Subject: Response to WDNR Correspondence dated August 11, 2022  
One Hour Martinizing (Former)  
301 Main St., Racine, Wisconsin 53403  
BRRTS No. 02-52-552198 / FID No. 252010990  
Project No. 1E-2109011

Giles Engineering Associates, Inc. (Giles) has prepared the following response to the Wisconsin Department of Natural Resources (WDNR) comments and concerns presented in their correspondence dated August 11, 2022. The WDNR has requested that the following comments and concerns be addressed including:

## Utility Line Layout - Notes

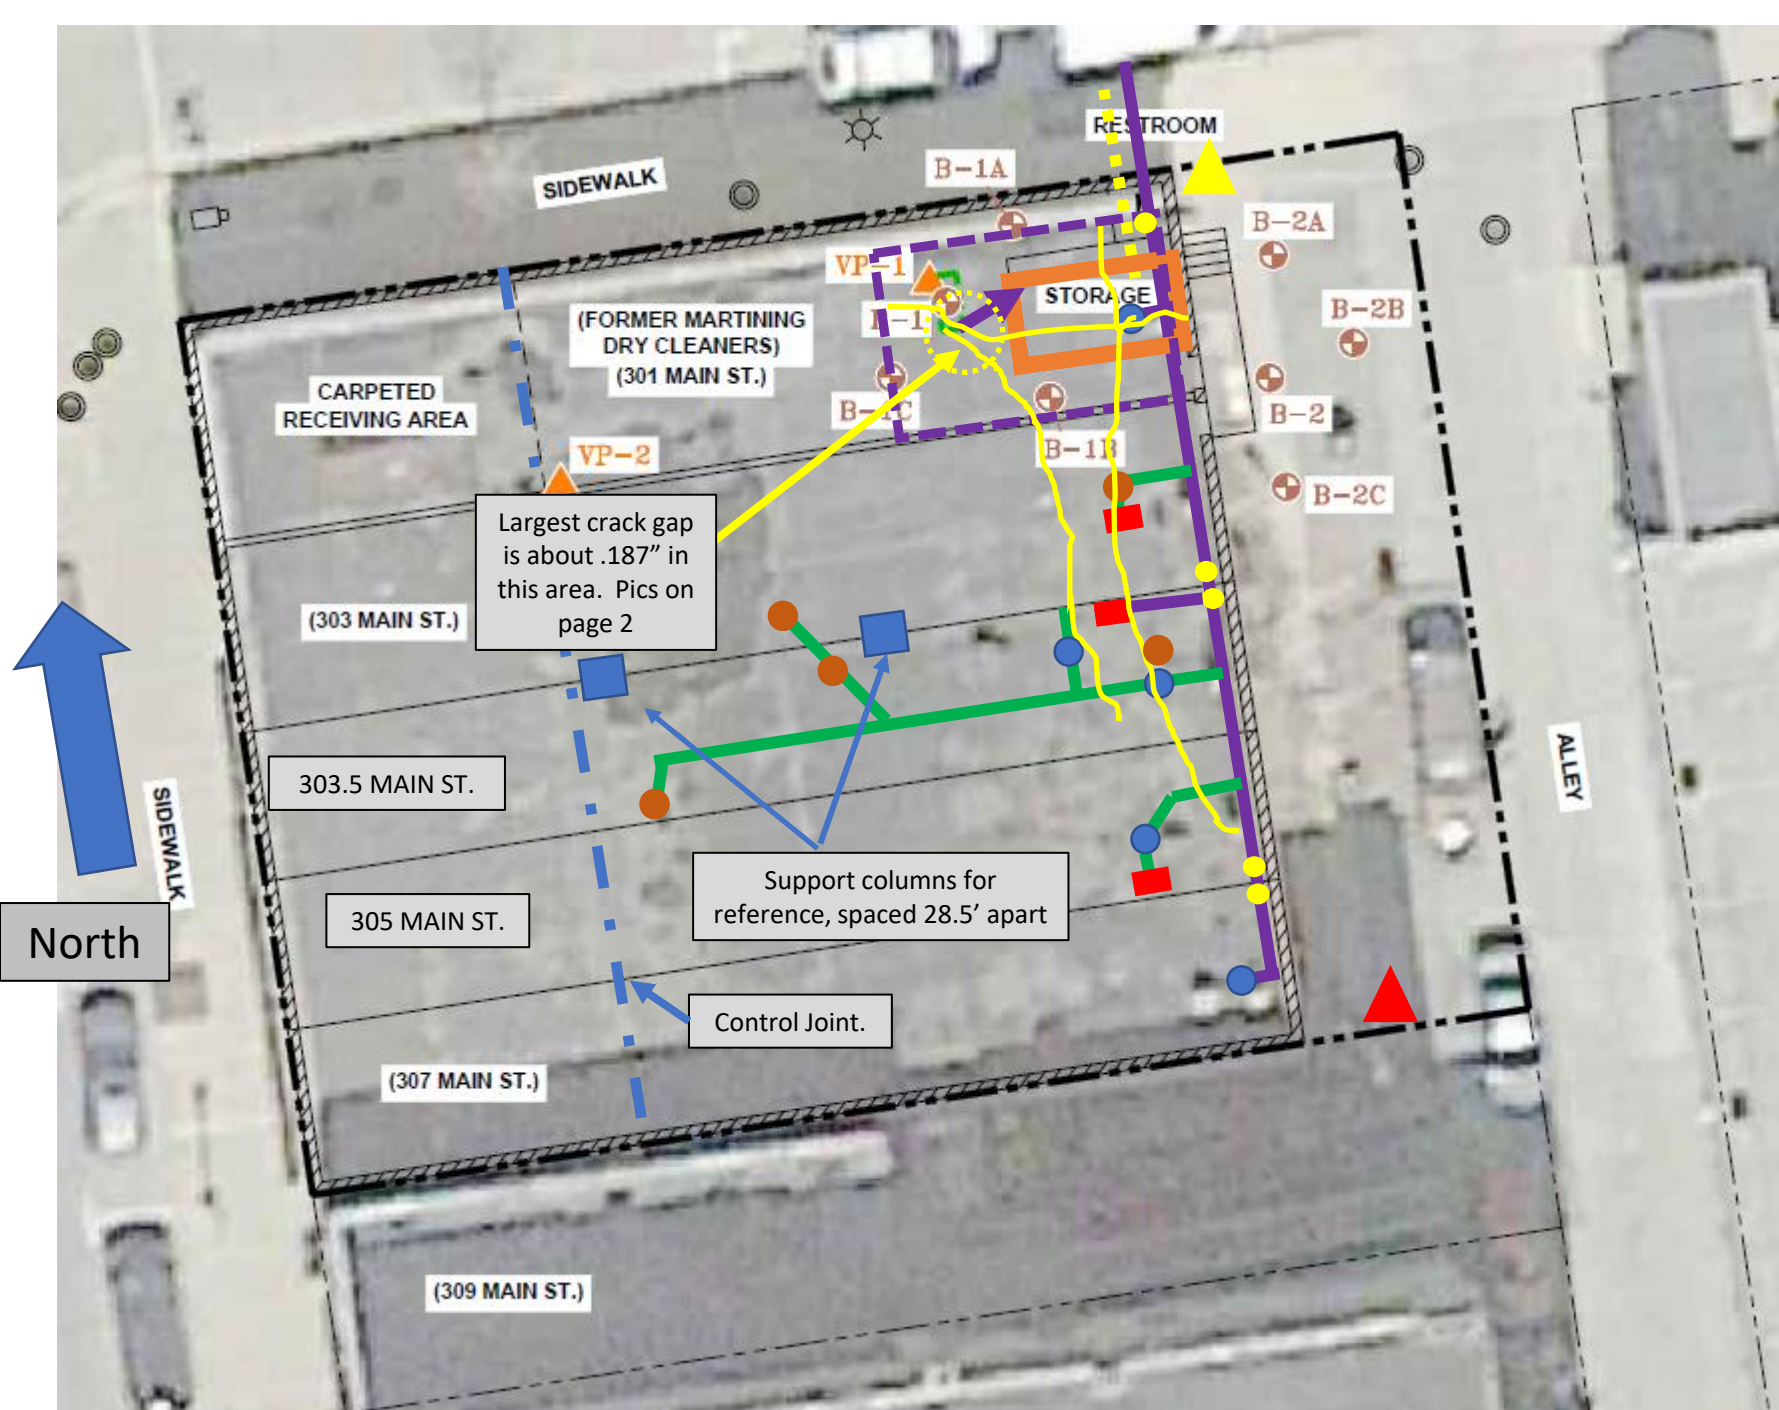
**4. Provide a figure showing locations of all floor drains and or cracks in the floor near the dry-cleaning machine that would be potential migration pathways.**

Mr. Jason Berry the Responsible Party (RP) presented Giles a map of subsurface utility's including photo documentation of floor drains and cracks in the floor, and photo documentation of the exterior. Units 305 Main St. is occupied by Creative Flex Studio and unit 307 is occupied by Rise Up Piercings and Tattoo with the remaining units vacant (301, 303 and 303.5). The maps and photos from the RP are presented as Attachment 1.
